**Conway Planning Commission  
Staff Report**

**7:00pm • February 21, 2017 • 810 Parkway Avenue**

### CONWAY CITY PLANNING DEPARTMENT REVIEW LEWIS RANCH PHASE II PRELIMINARY PLAT SUBMITTED BY: WILLIAM MAJOR LEWIS TRUST

CONWAY CITY PLANNING DEPARTMENT REVIEW  
 CAMPBELL COVE PUD PRELIMINARY PLAT  
 SUBMITTED BY: HAL CRAFTON

Preliminary Plat

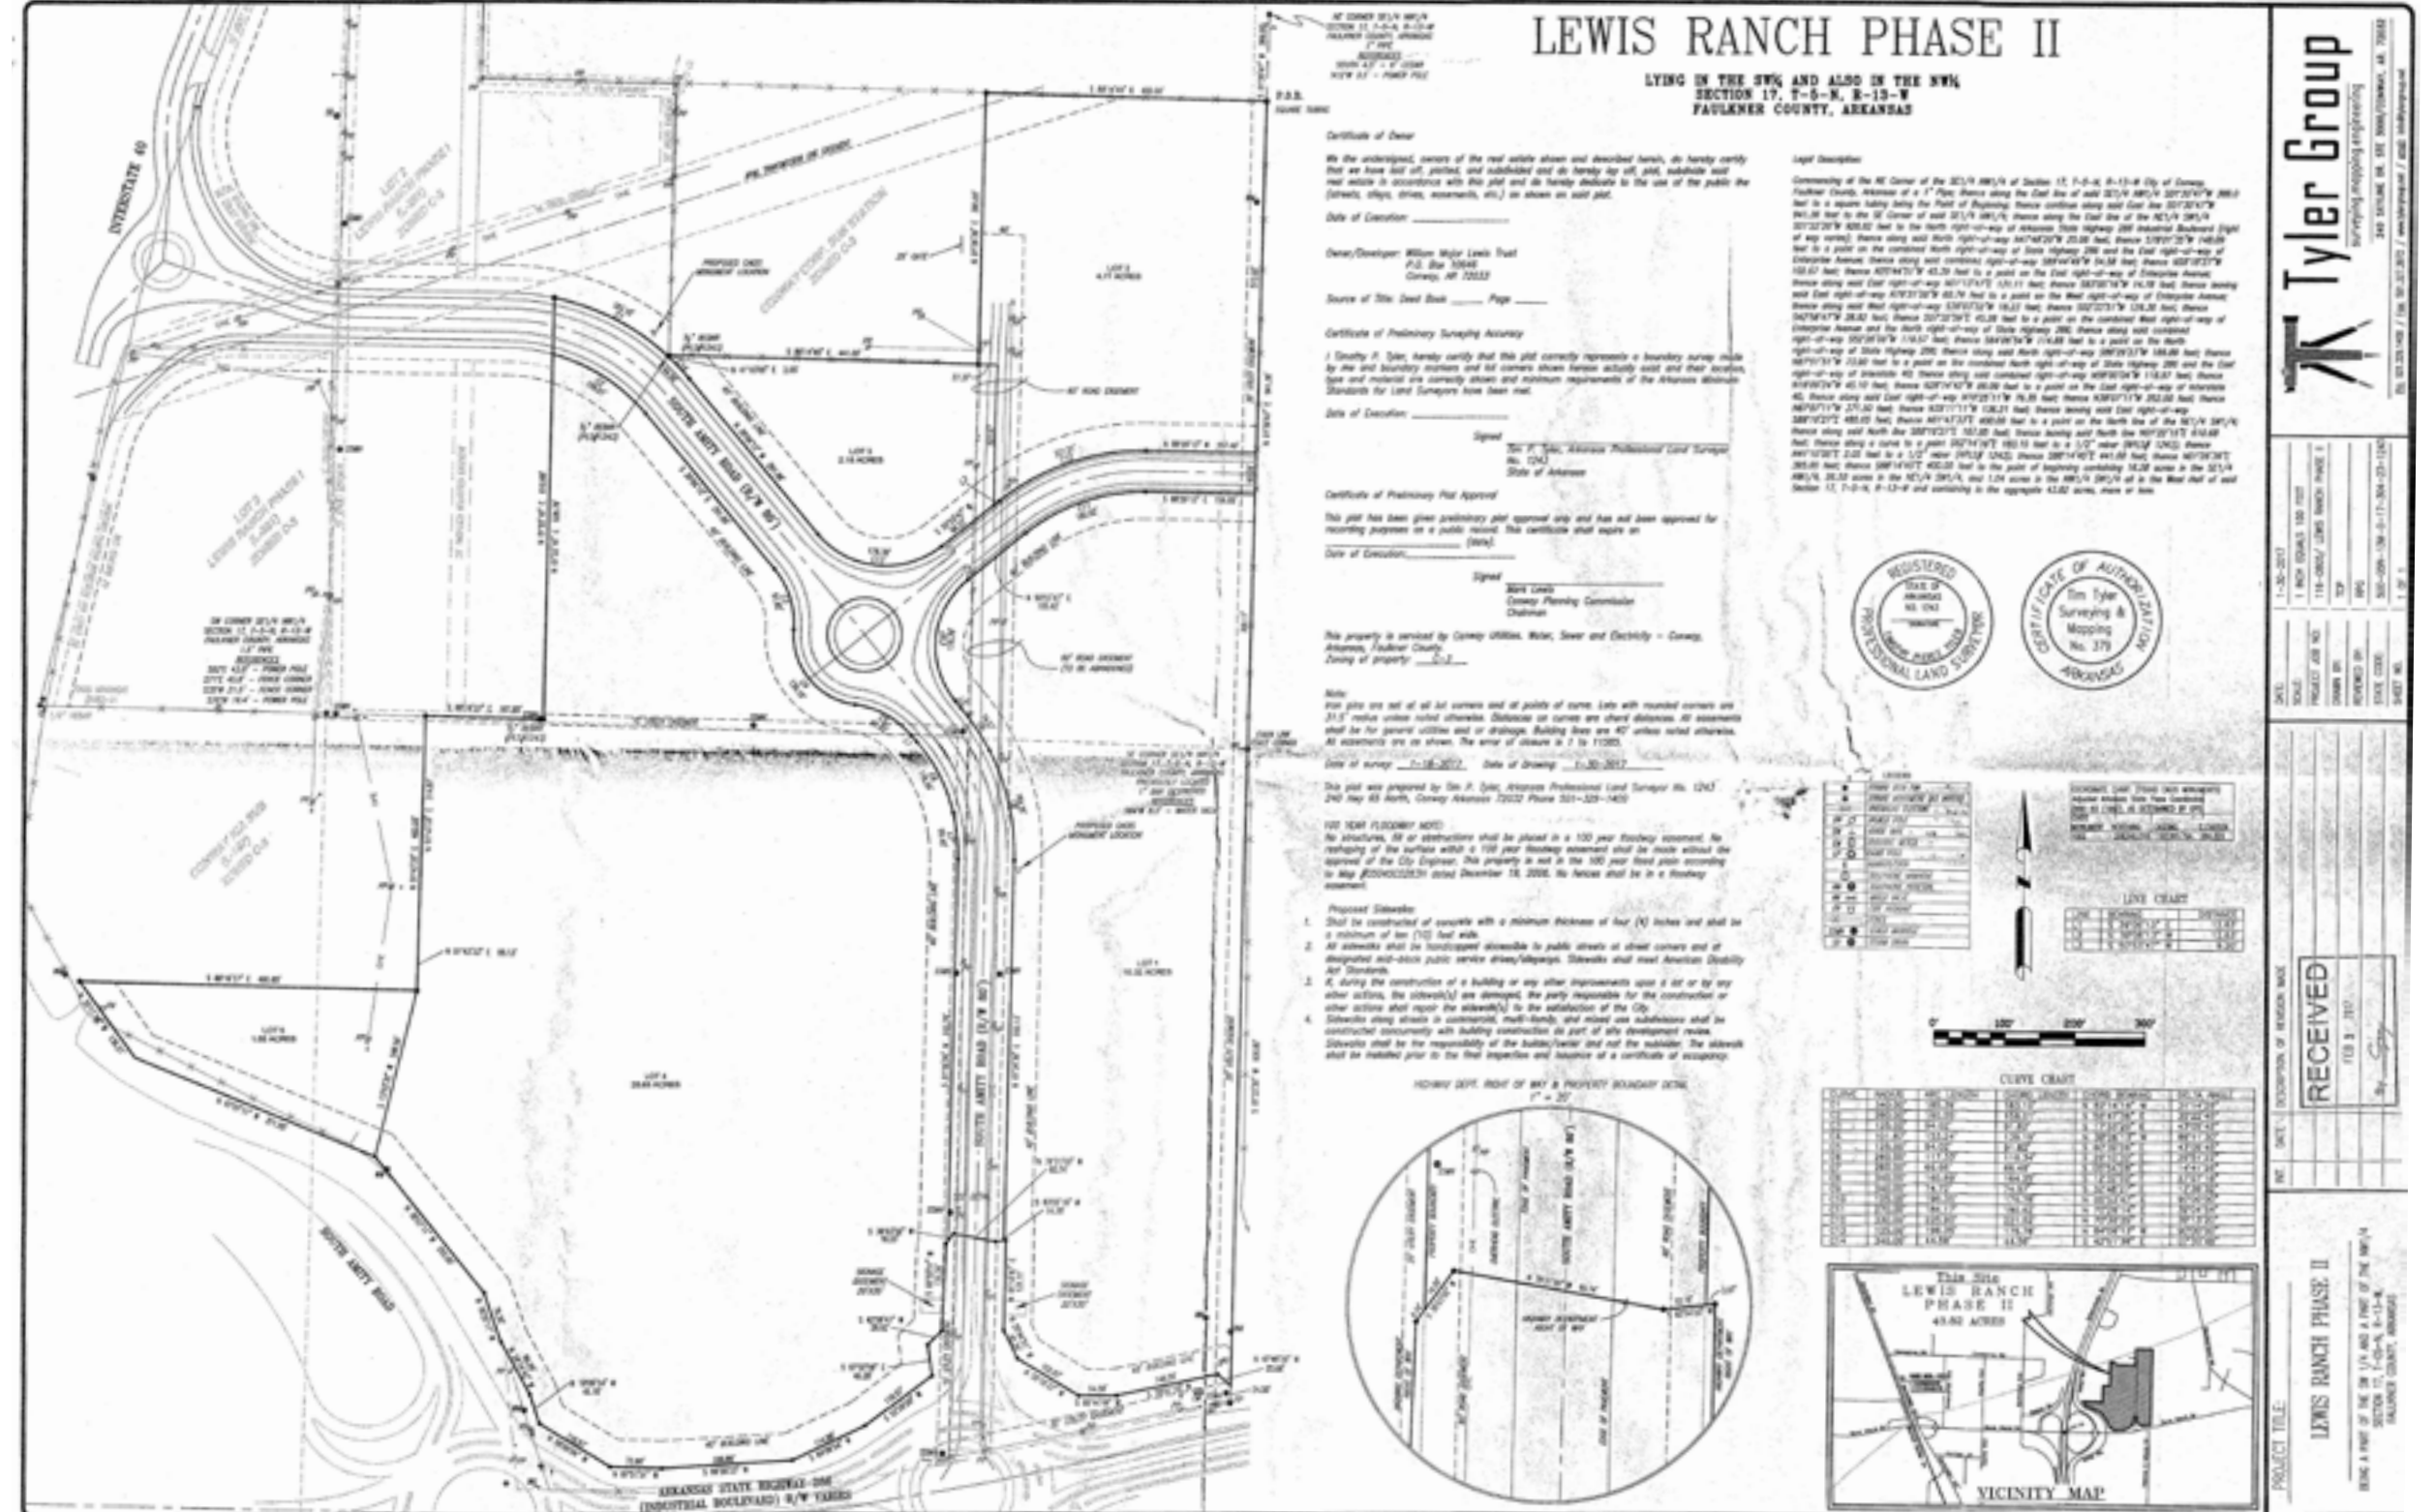
1. The present zoning classification, if any, of the land to be subdivided/replatted and of the adjoining land contiguous to the boundary of the proposed subdivision/replat is needed.
2. The Certificate of Preliminary Plat Approval is needed. Change Signor to "Anne Tucker, Chairman"

1. A draft of any Bill of Assurance proposed for the subdivision generally describing proposed covenants, restrictions and conditions applicable to the property included in the submitted plat is needed.

1. The development plans shall include and identify a prepared and dedicated flowage path or floodway that will accommodate a one hundred (100) year frequency storm event across and through the development. The floodway shall be uniformly graded along the length of the floodway such that water will not pond or accumulate on the surface due to humps or depressions along the route. Computations for the quantity of storm water runoff, sizing of the floodway and elevation of the one hundred (100) year flood shall be prepared by a registered professional engineer and submitted to the City Engineer for review and approval. The computations shall be made using usual and accepted methods and procedures as approved by the City Engineer. A floodway will not be required where less than five (5) acres of adjacent lands drains onto the developed property and the total drainage area is less than five (5) acres.

2. An easement of adequate width to accommodate the required floodway shall be provided on the plat. The easement shall clearly identify the easement as a "100-year Floodway". The plat shall have a note that reads as follows: "No structures, fill or obstructions shall be placed in the 100 year Floodway easement. No reshaping of the surface within the 100 year Floodway easement shall be made without the approval of the City Engineer. No fences shall be in the floodway easement."

6. Utility easements as required by Conway Corporation are needed.
7. Drainage easements as required by the City Engineer are needed.

8. Every lot must slope to a street or to a drainage easement.

9. Fire hydrants shall be placed so that the furthest point of a lot in a commercial subdivision is no more than 400 feet from the nearest hydrant located on the same street. Variances must be approved by the Planning Commission and Fire Chief.
10. Minimum clearance of twenty-six (26) feet must be provided around a fire hydrant.

11. Sidewalk elevation. The sidewalk elevation shall be two (2) percent above the top of the curb, sloping two percent towards the curb (one-fourth inch in each foot). This elevation shall be continuous through the driveway approach.
12. Driveway approach. The area remaining between the sidewalk and the flow-line of the gutter, called the approach to the driveway, shall slope up to the elevation of the sidewalk.
13. Sidewalks shall link sidewalks of adjoining lots so as to provide a continuous "ribbon" of pedestrian access throughout the community.

Staff recommends approval of the preliminary plat subject to the completed punch list.

Preliminary Plat

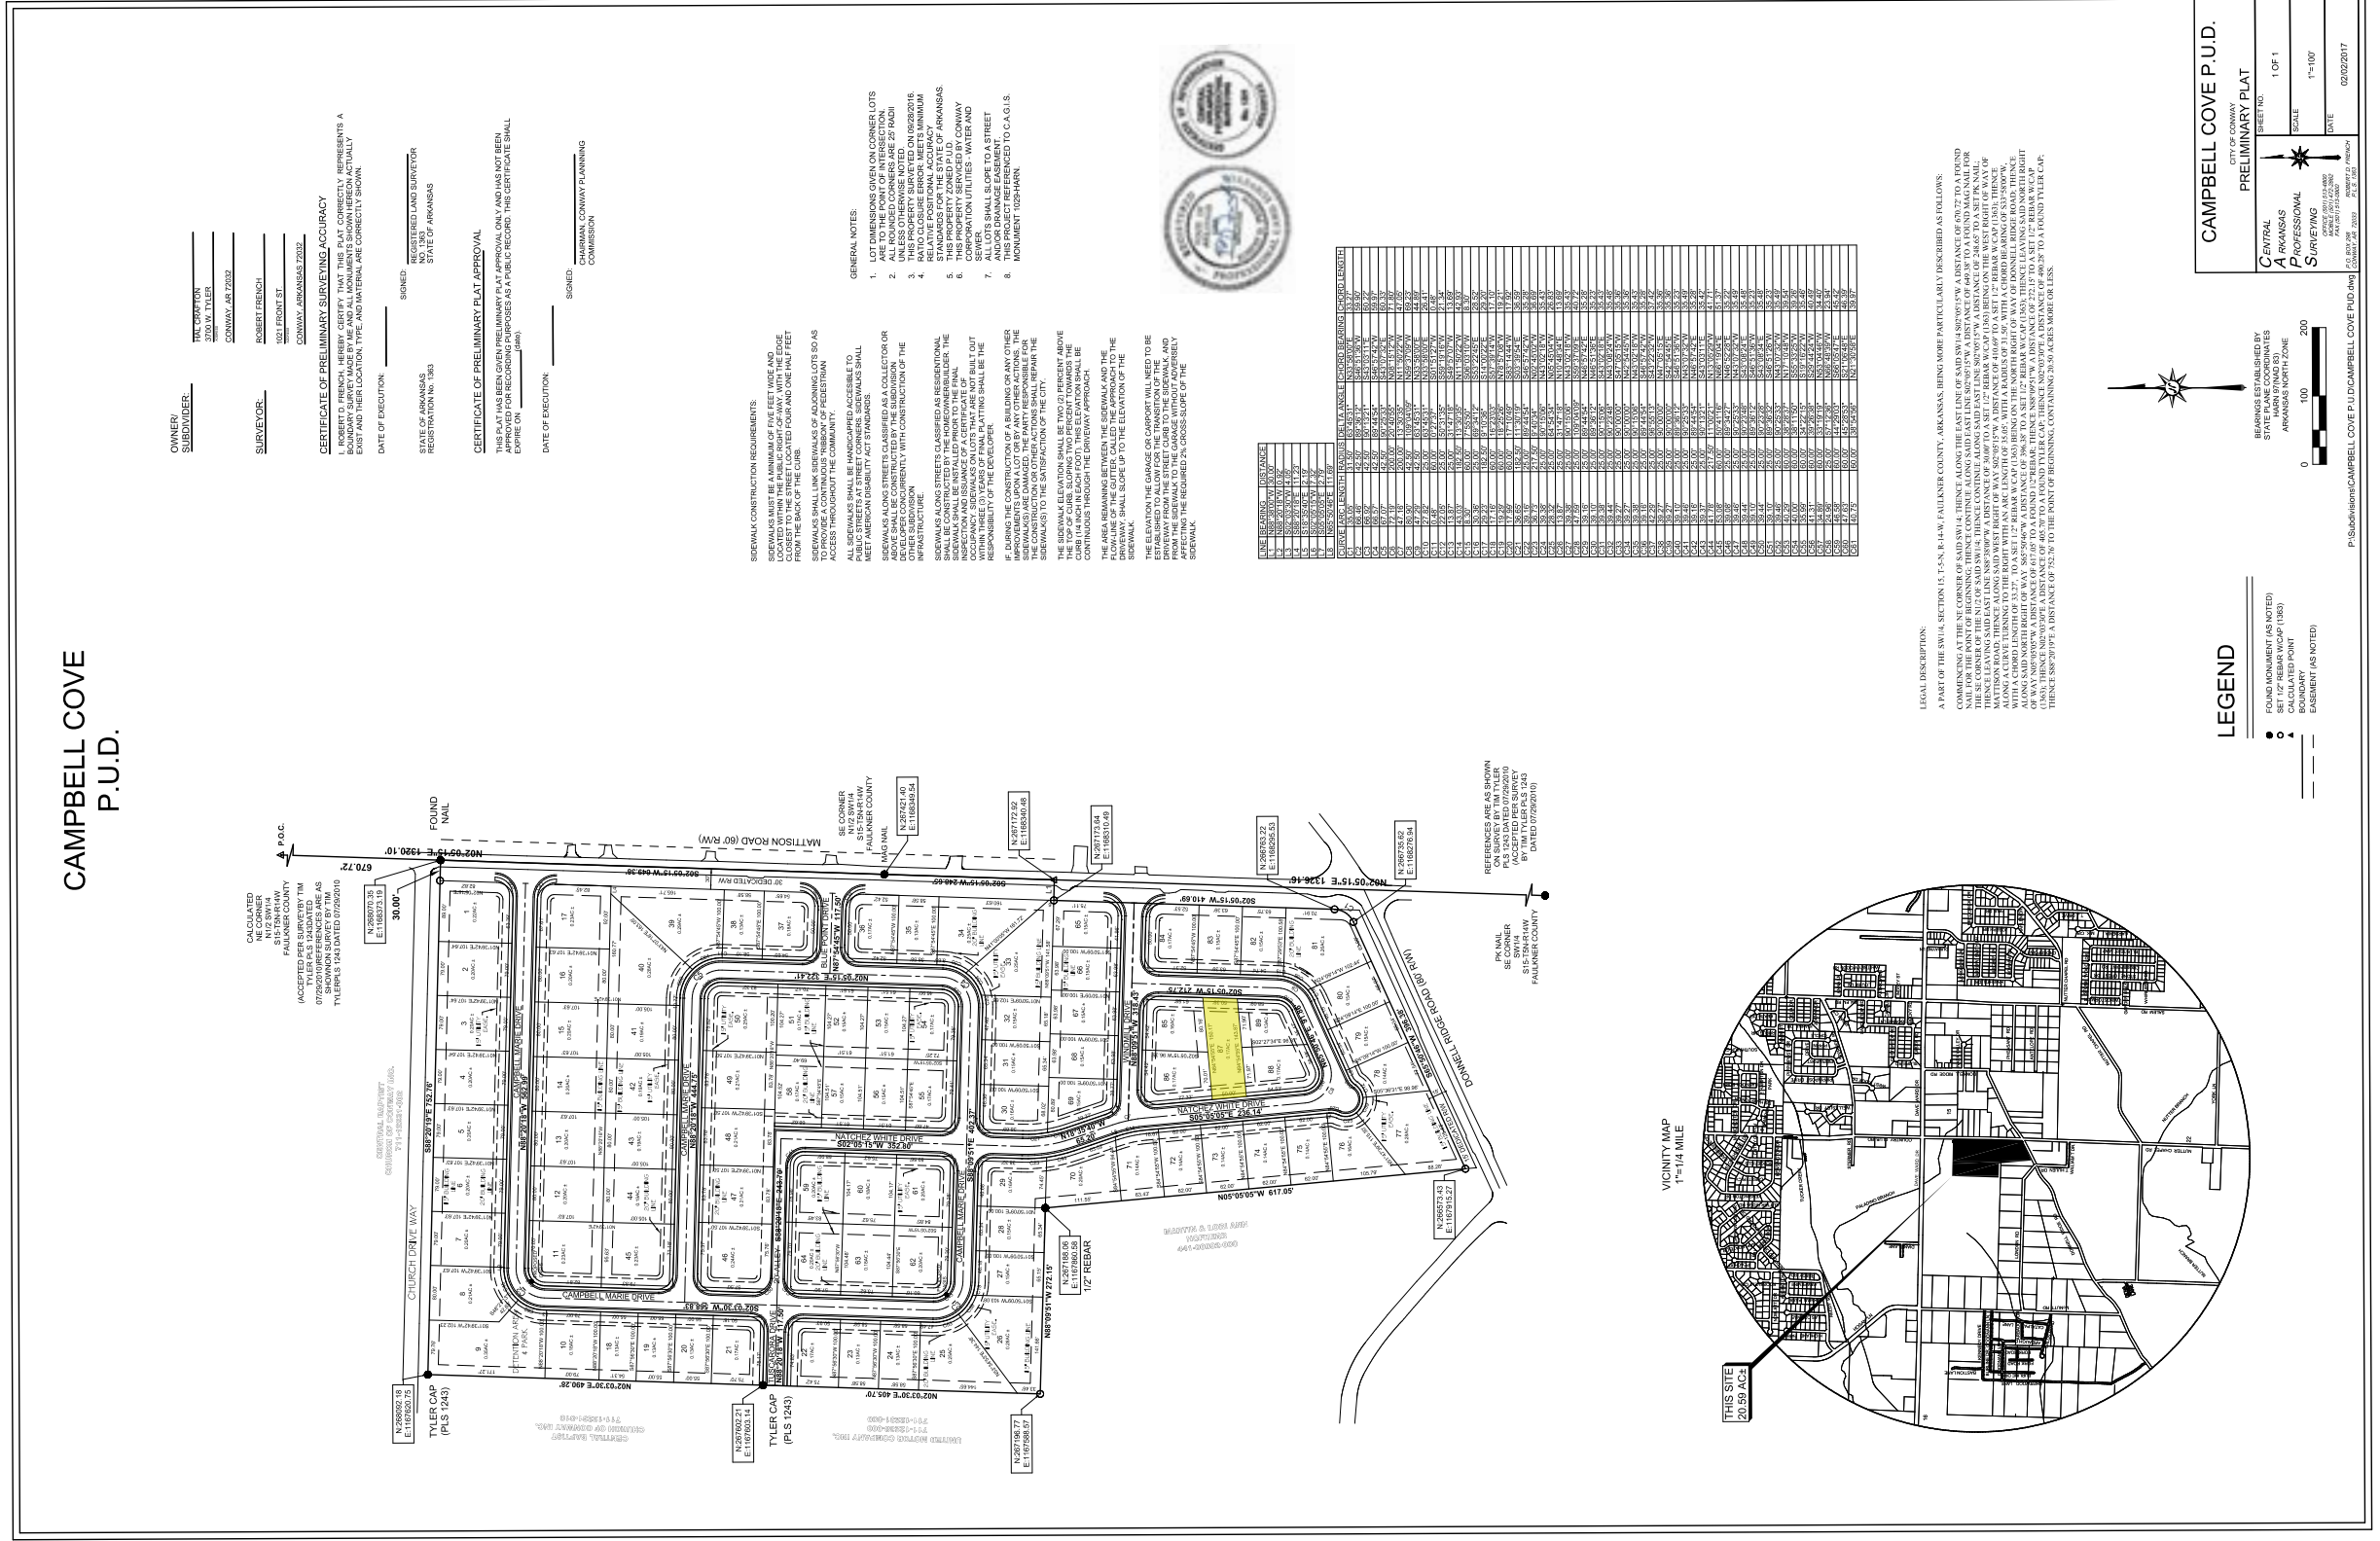
1. Lot lines with appropriate dimensions are needed.
2. A phasing plan outlining the boundaries for each phase and the location of all CAGIS monuments for the subdivision is needed. A minimum of two CAGIS monuments shall be placed in each subdivision or subdivision phase exceeding ten (10) acres. For subdivisions of ten (10) acres or less in size, no new CAGIS monumentation is required. However, these smaller subdivisions must all be tied to CAGIS monumentation.

3. Improvement plans for each new utility system are needed.
4. The Certificate of Preliminary Engineering Accuracy is needed on each set of street and drainage plans.

11. The rights-of-way of all streets must conform to the Master Street Plan and the requirements of Table 1, Street Classification & Design Standards, City of Conway in the Subdivision Ordinance. *Donnell Ridge Road requires 80' ROW, so additional dedication of 15' is required.*
12. Property line corners at street intersections shall be rounded with a radius of at least 28 feet. ***A variance request has been received to allow corner radii of 25 feet due to the approved PUD reduced street rights of way. The Planning Commission must approve this variance or this condition must be corrected.***

20. Double frontage lots other than corner lots fronting on two streets shall not be platted except under extreme circumstances, as may be approved by the Planning Commission. **Planning Commission must approve lot 87 as a double frontage lot or this condition must be corrected.**

21. Sidewalks are required along both sides of all streets within all zoning districts within Conway city limits and within the Conway Territorial Jurisdiction. *A minimum green space of three (3) feet should be provided between the sidewalk and curb along residential streets for developer required street trees.*

Planning Commission approval is needed for items 12 and 20. Staff recommends approval of the preliminary plat subject to the completed punch list.
